# Manual Supplement

Manual Title:	381 Calibration	Supplement Issue:	<b>4</b>
Part Number:	Web Only	Issue Date:	4/17
Print Date:	December 2010	Page Count:	3
Revision/Date:	1, 6/12

This supplement contains information necessary to ensure the accuracy of the above manual.

Figure 7. Current Test Simulated Voltage

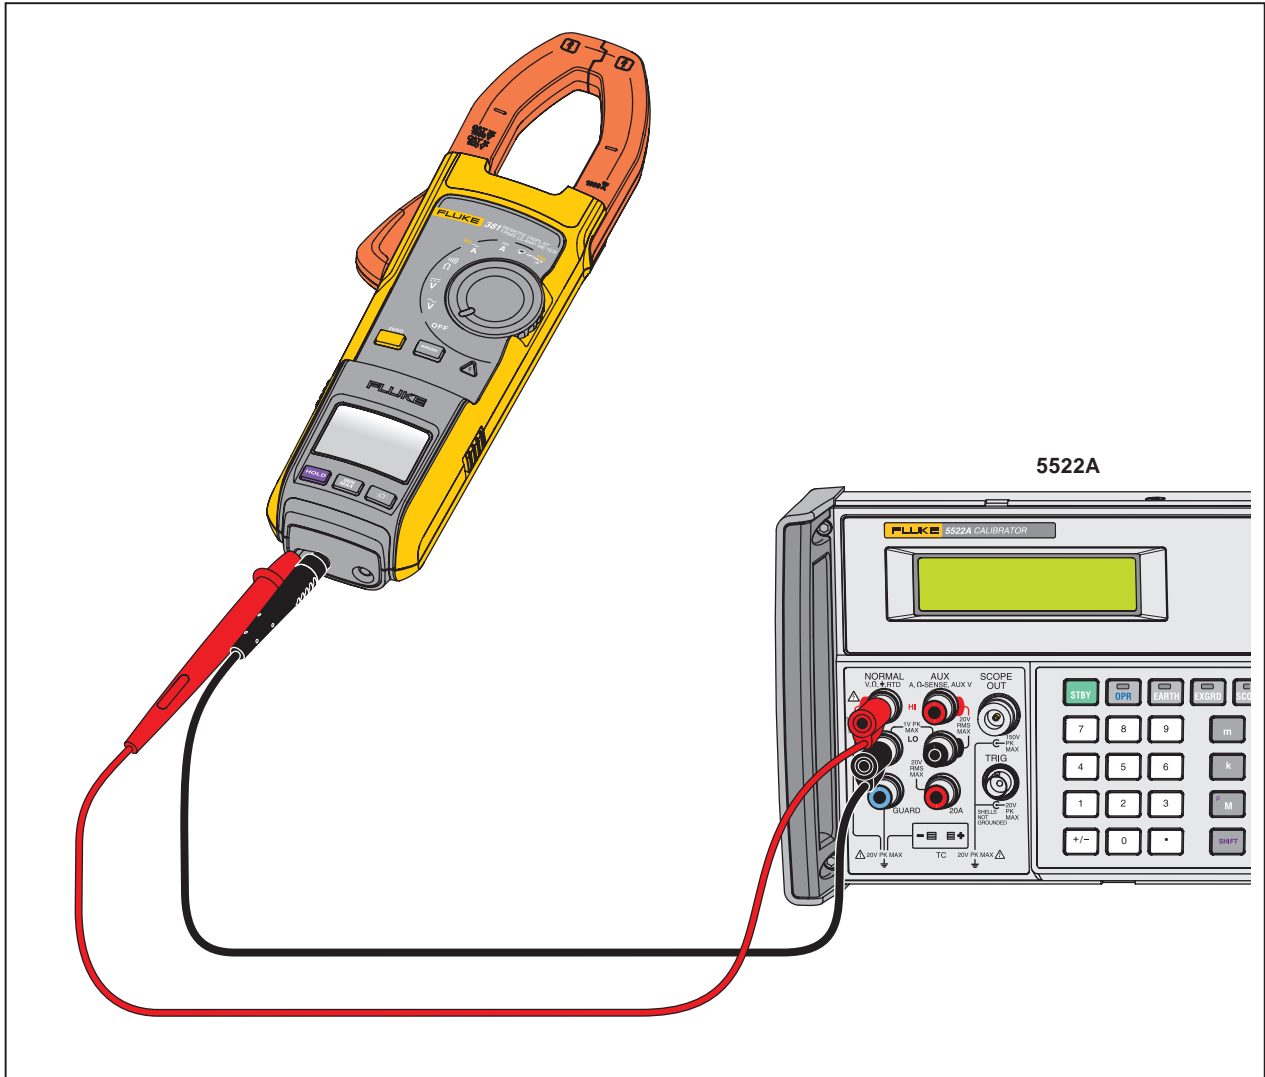
On page 14, replace Figure 7 with:

Figure 5. Performance Test Connections for AC Voltage, DC Voltage, and Frequency

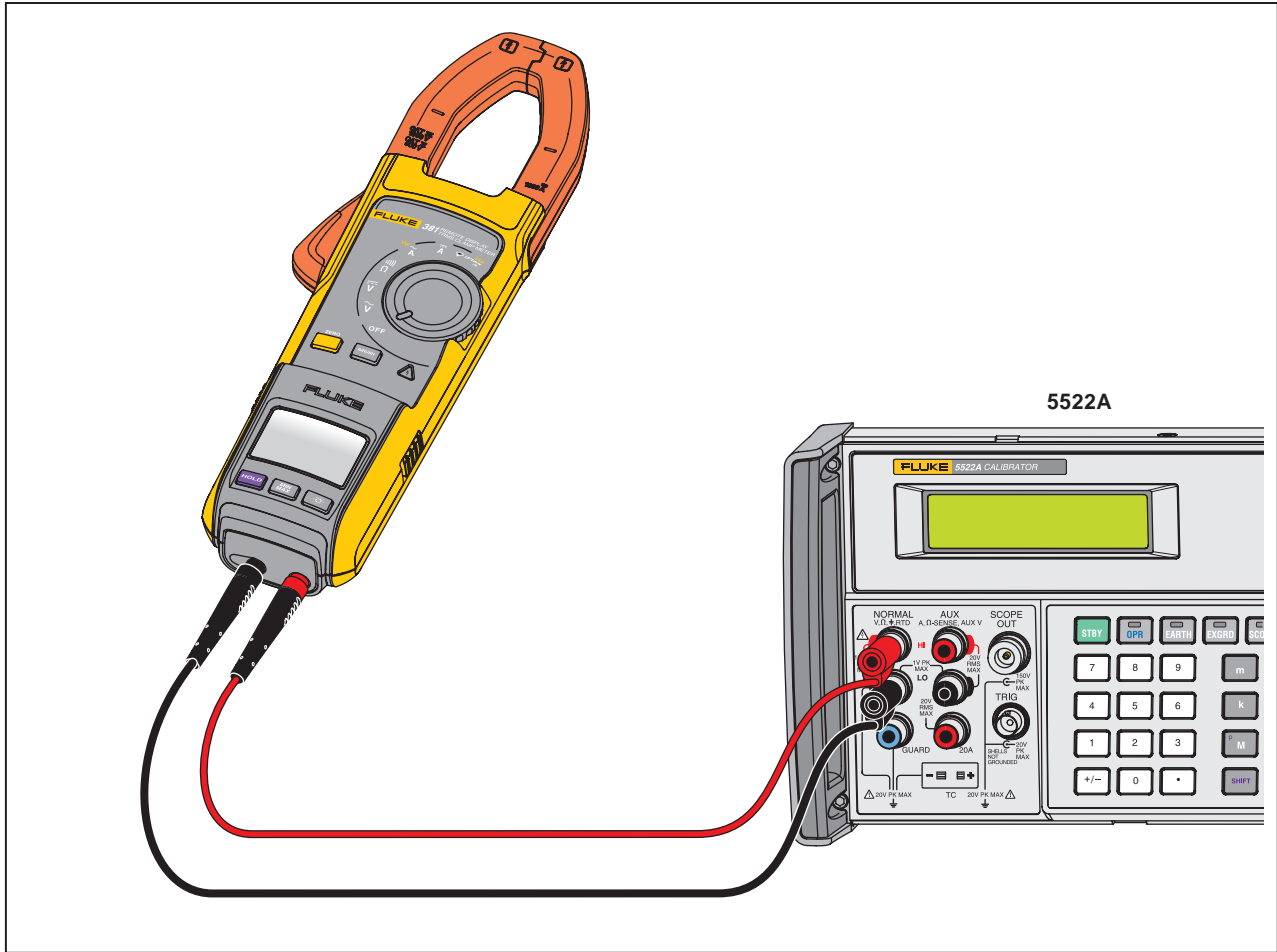
On page 10, replace Figure 5 with:
